**OBJECTIONS to development at Long Copse Lane, PO10 7UN
App/21/00893**

We have 2 principle objections to the proposed housing development in Long Copse Lane:

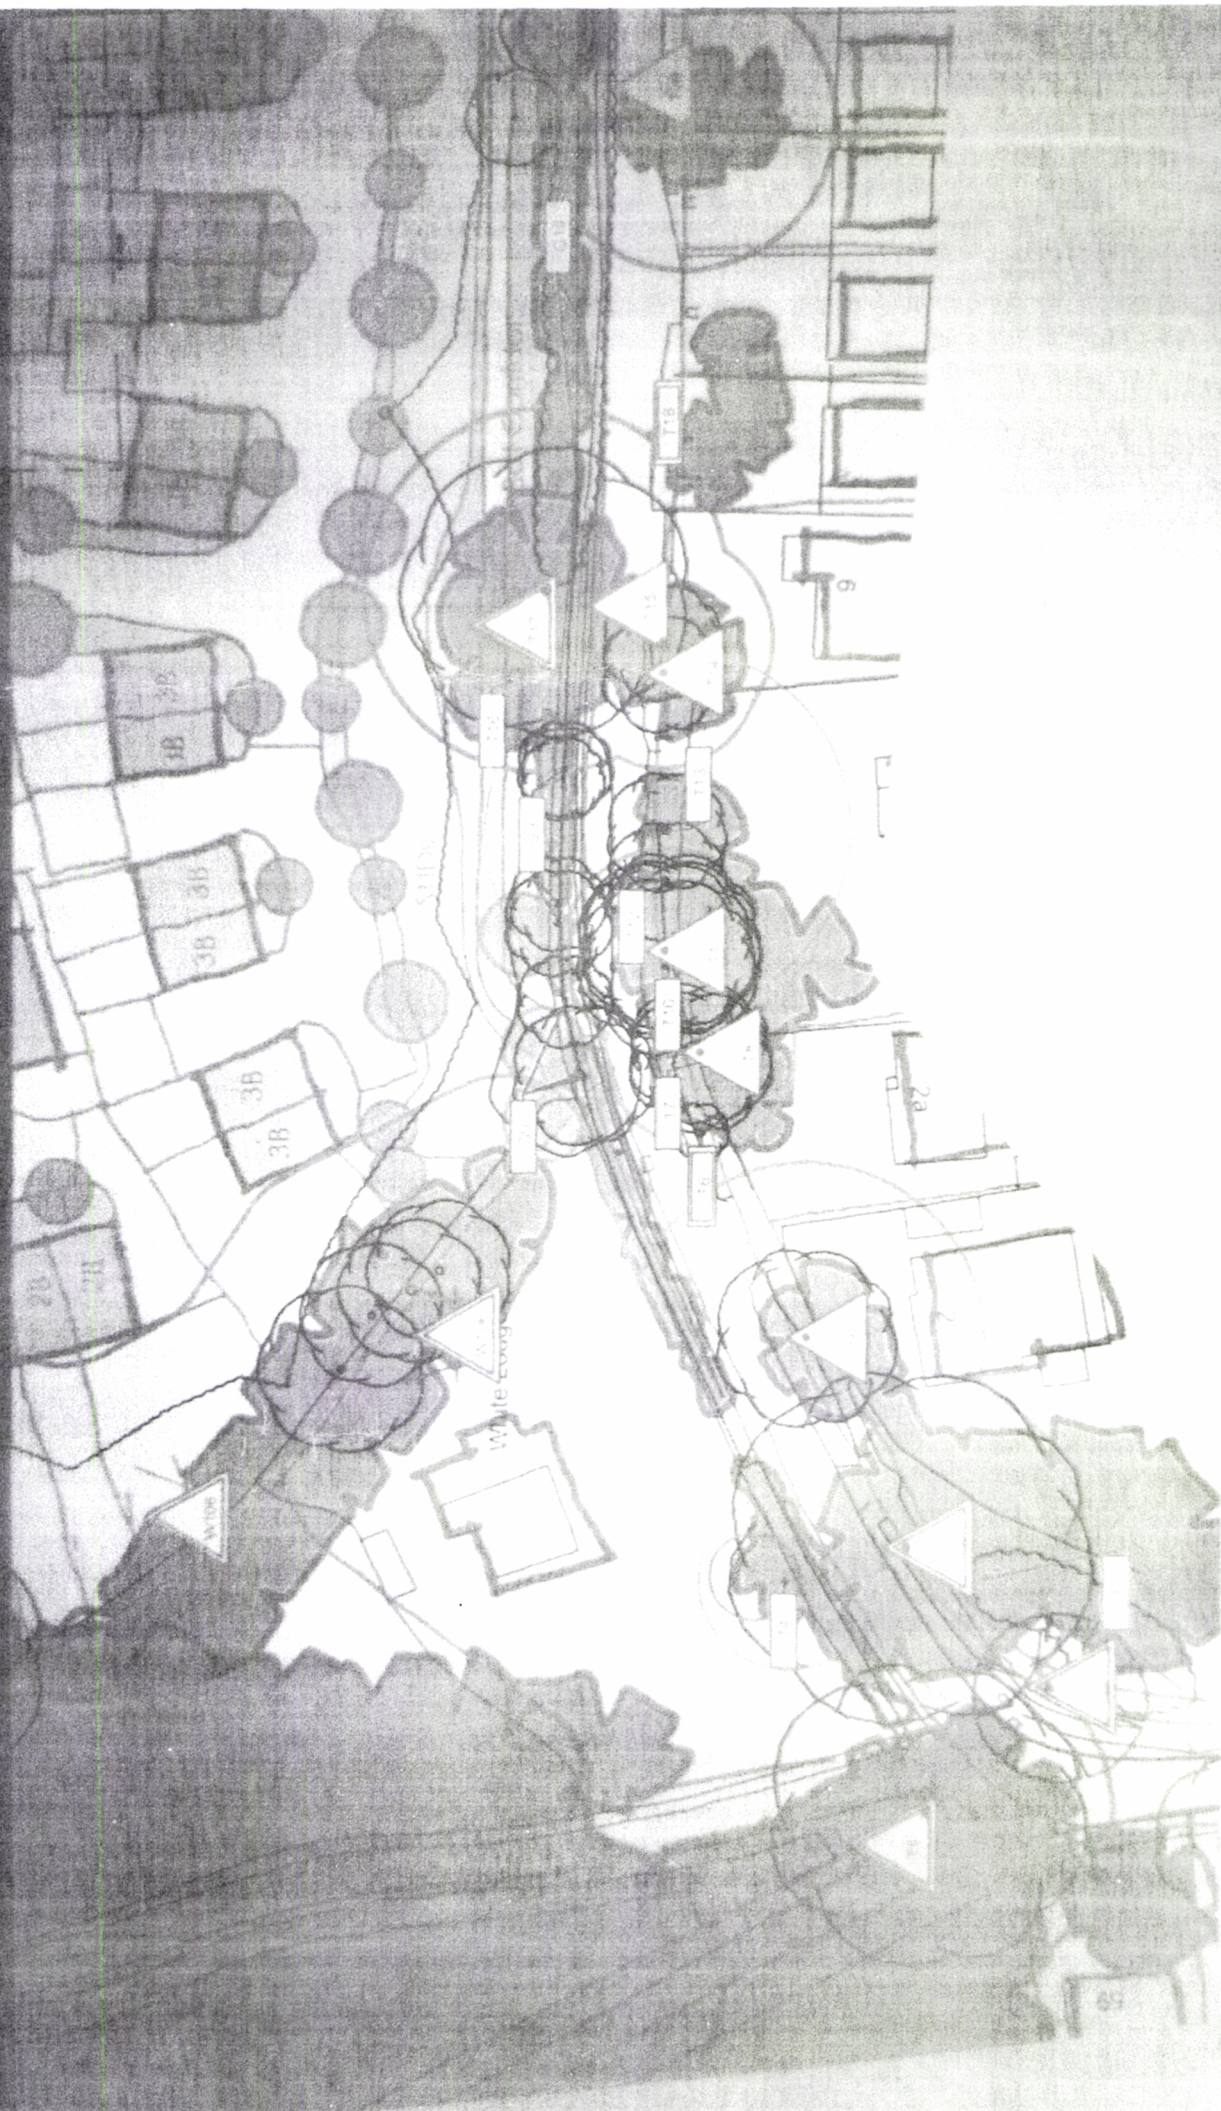
7.10.4 the inter-visibility assessment, for the east part of Long Copse Lane, (drawing ITB 13525-GA-019) shows cars in the most favourable positions for seeing directly ahead. At the eastern end, from the corner onward there are no passing places: cars park on the north side opposite the houses near North Street and if you meet another vehicle in this section it is necessary to back-up blindly into North Street or back-up to the corner; which we have had to do several times with just the current traffic flow.
